Access Compliance Report

Public Rights-of-Way

(Pedestrian Signals)

Intersection ID: N/A	Main Street:	Cross Street: N/A	Location: N/A
ADA ID: 12D75BDB0649	Signal Type: One Push Button-Non APS	Overall Compliance: No	Severity Score: BTN 1: N/A BTN 2: N/A No BTN: N/A
Codes/Mitigation Info/Possible Solution		Field Measurements/Component Compliance

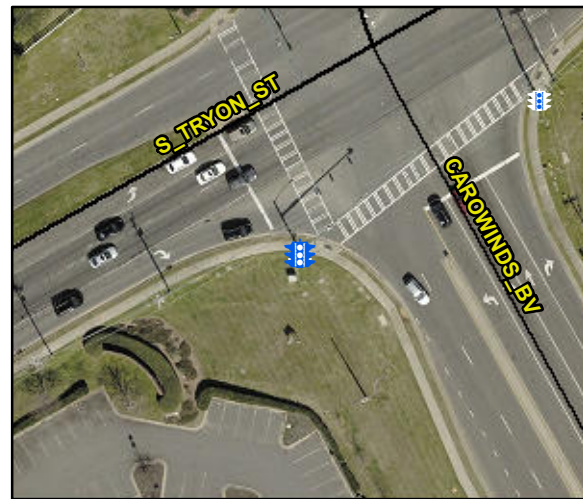
Surveyor Notes: TX HEIGHT 3/8

PROW/ADA: R410.6, TMUTCD 4e.08, R404.2, R404.3, R406.2, R404.7.3

Possible Solutions: Replace Signal Push Button With APS Button on New Post. Remove & Replace Sign.
